Product Change Notification (PCN)

PCN #: 2D-2026

Date: February 06, 2026

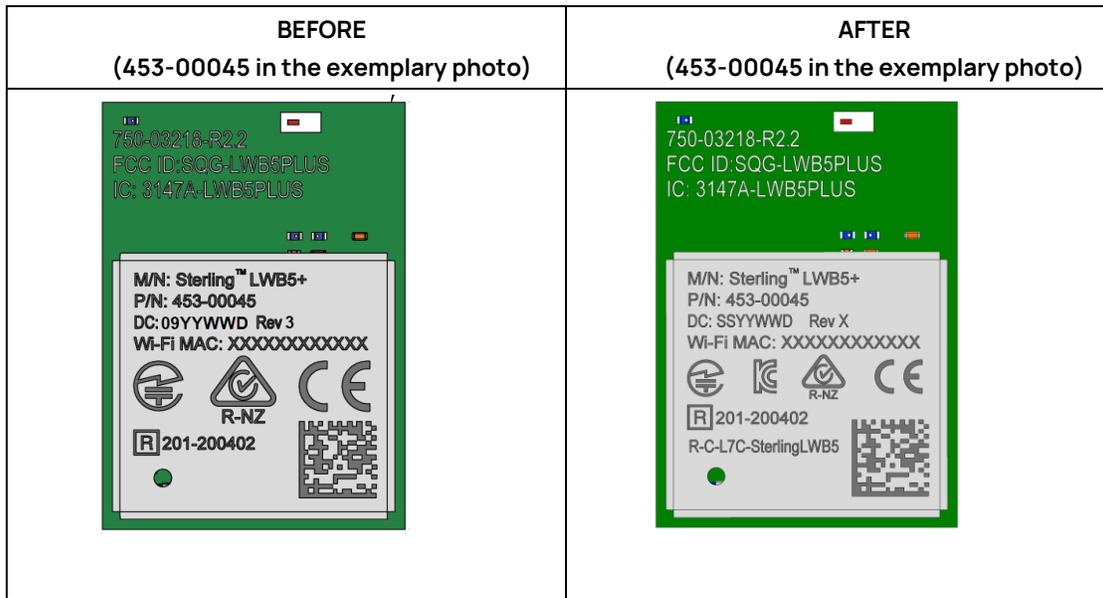
- Update device label to include KC ID and logo to identify South Korea certification

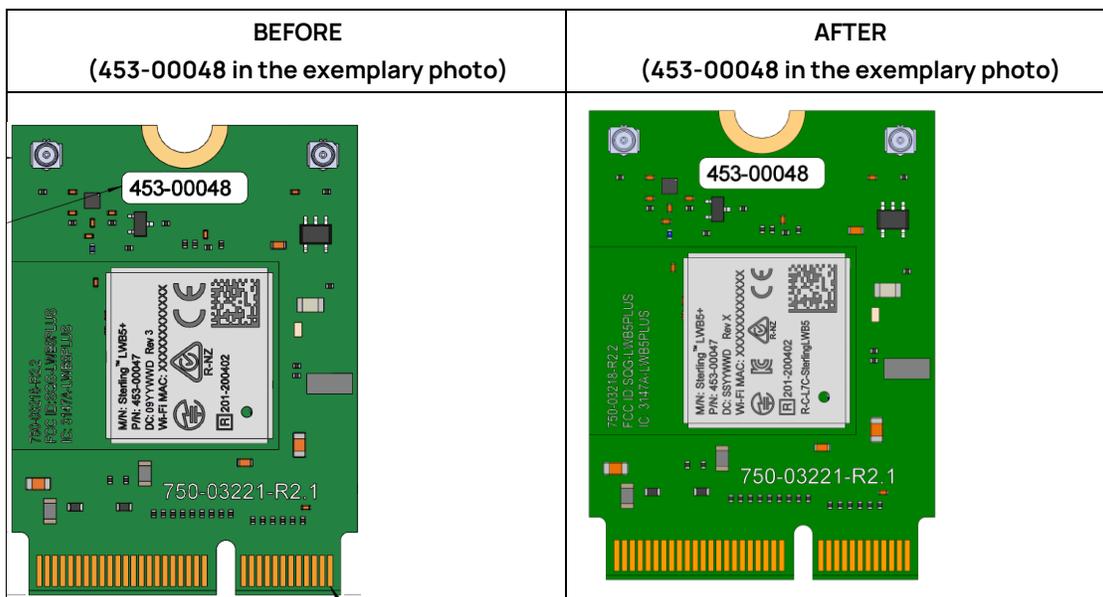
- 453-00045R/453-00045C/453-00046R/453-00046C/453-00047R/453-00047C
 - On the device laser-etching adds KC logo and ID

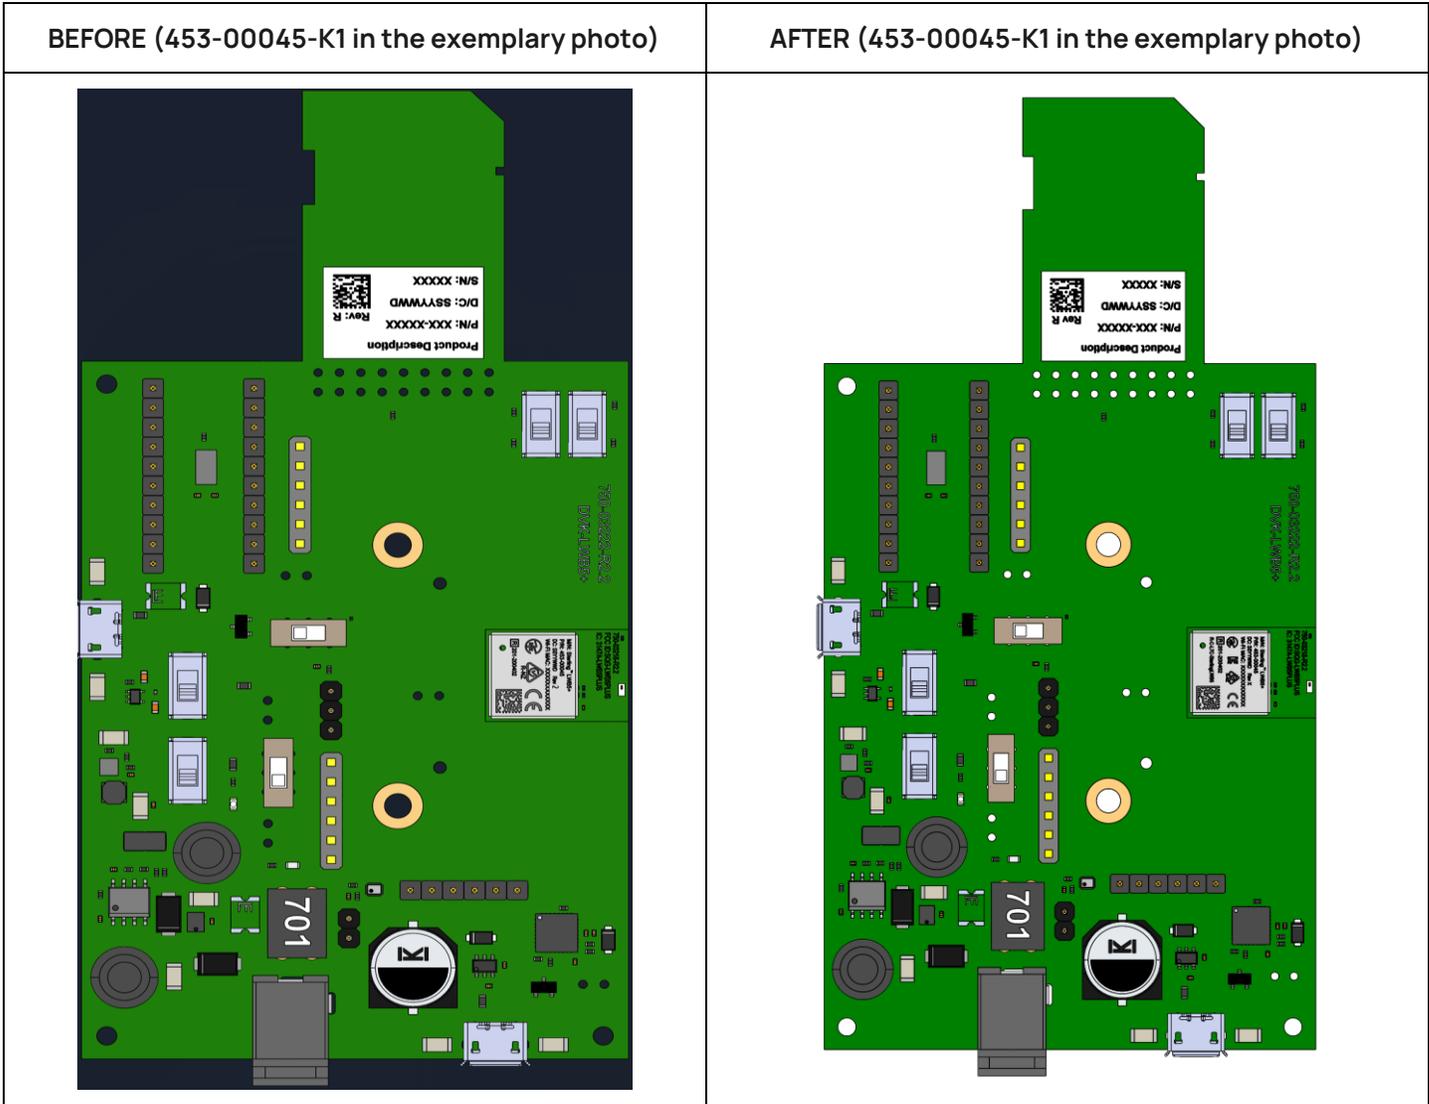
- 453-00048/453-00049
 - On the device laser-etching adds KC ID and logo

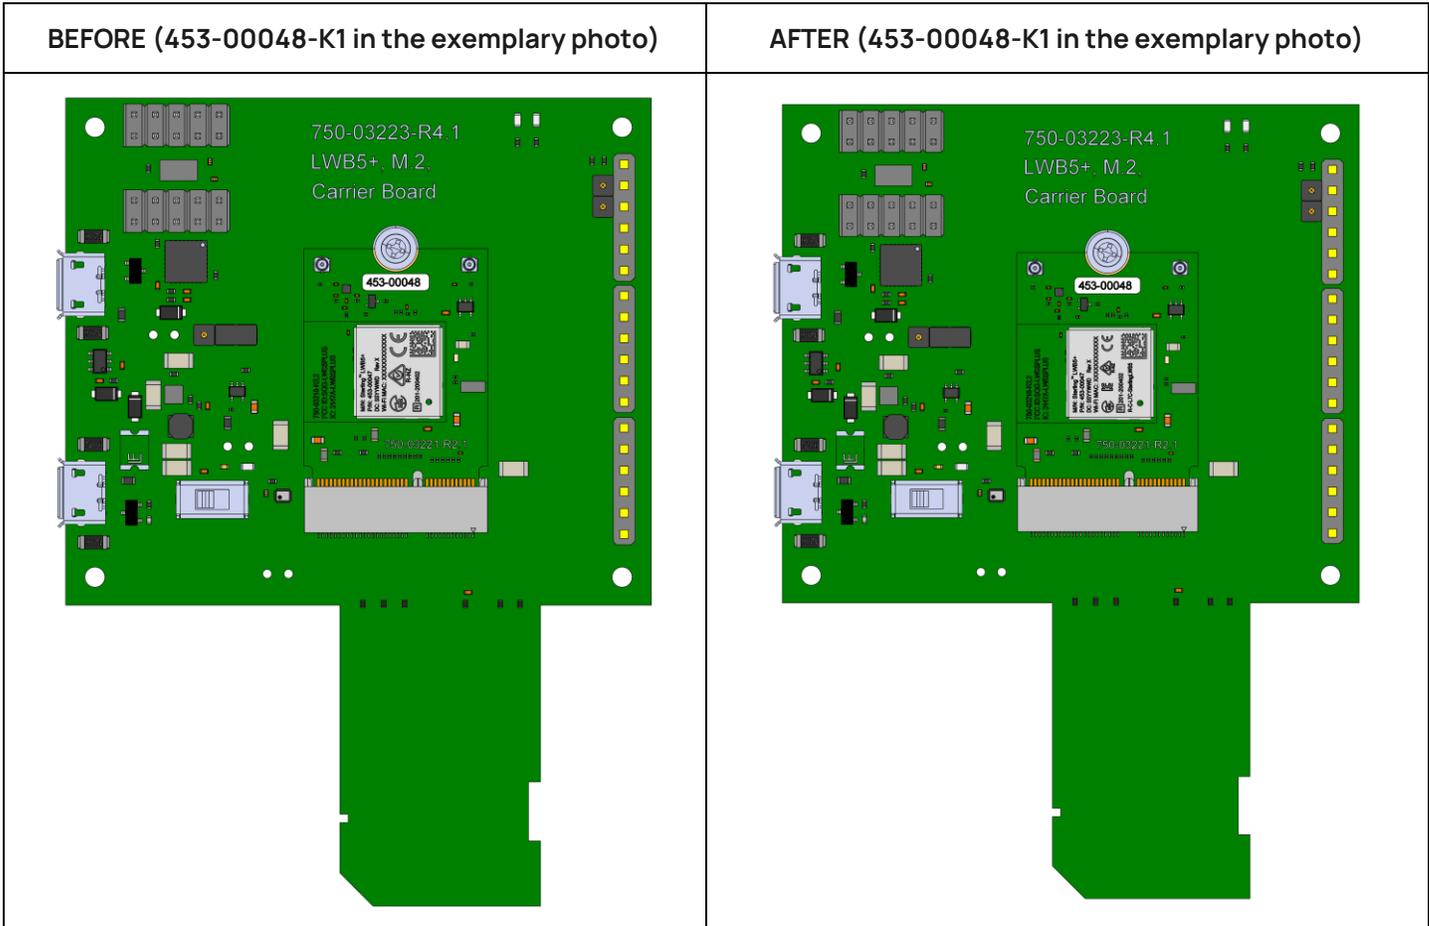
- 453-00045-K1/453-00046-K1
- On the PCBA, the module adds KC ID and logo

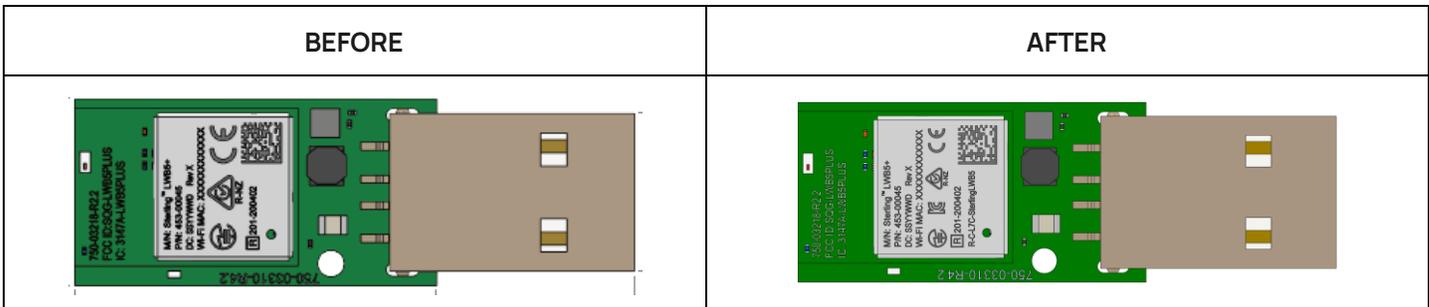
- 453-00048-K1/453-00049-K1
- On the M.2 module, the module adds KC ID and logo

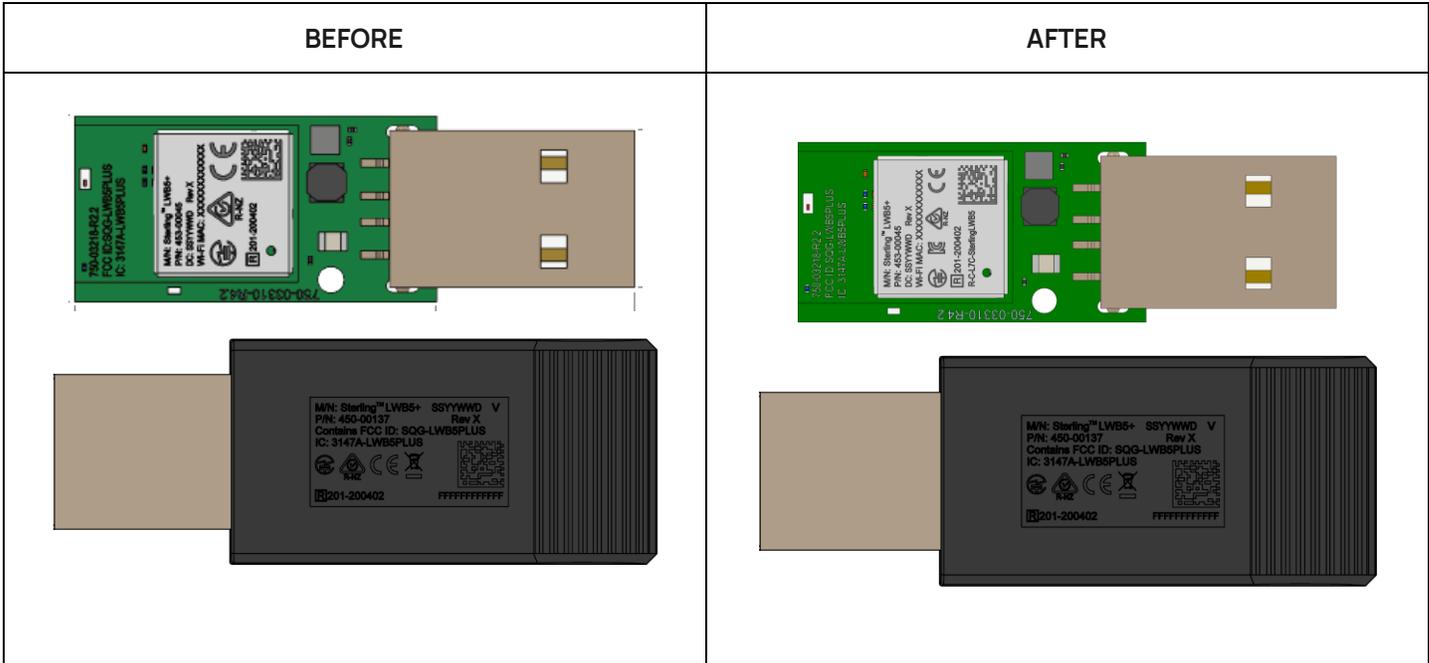
- 450-00179/450-00179B
- On the PCBA, module adds KC ID and logo
